## Standards Update Transmittal

Reference Number: 2024v-10  
Standards: SD-6.1 & SD-6.2, SCS Section 19-2.02

**STORM DRAIN PLASTIC PIPE  
BEDDING AND INITIAL BACKFILL**

SD - 6.2

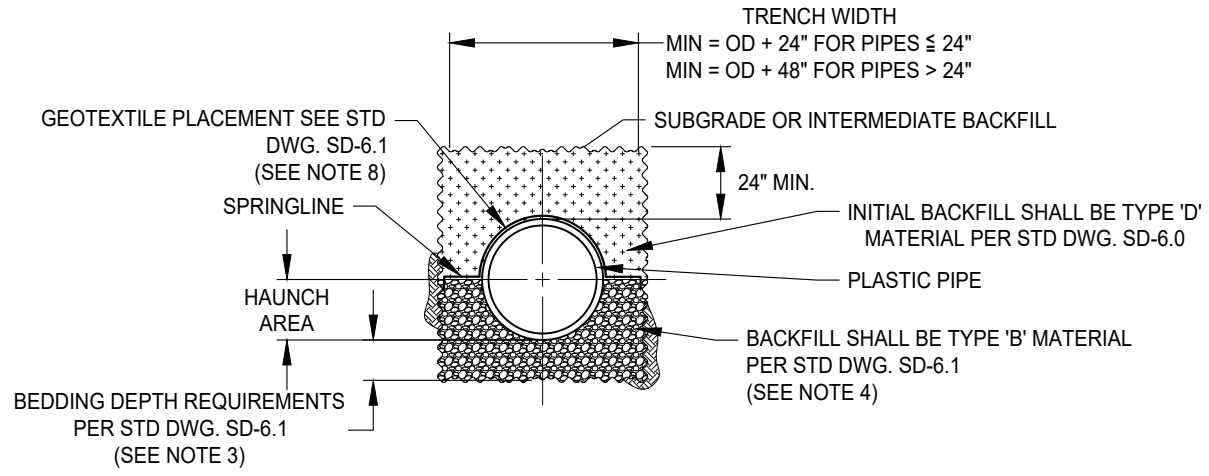
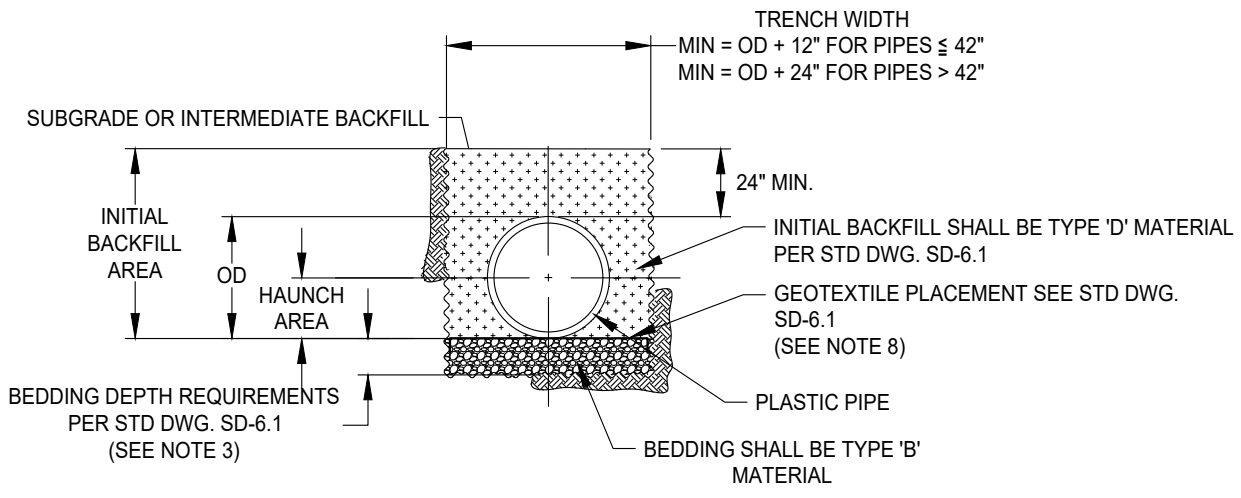
1. Modification to SD-6.1 & SD-6.2:
  - a. Reducing the trench width for 24" or smaller pipes from 36" to 24".
2. Modification to SCS Section 19-2.02:
  - a. Adding the tamper rammer as mechanical compactor option due to reduced trench width where a vibratory plate compactor may not fit.
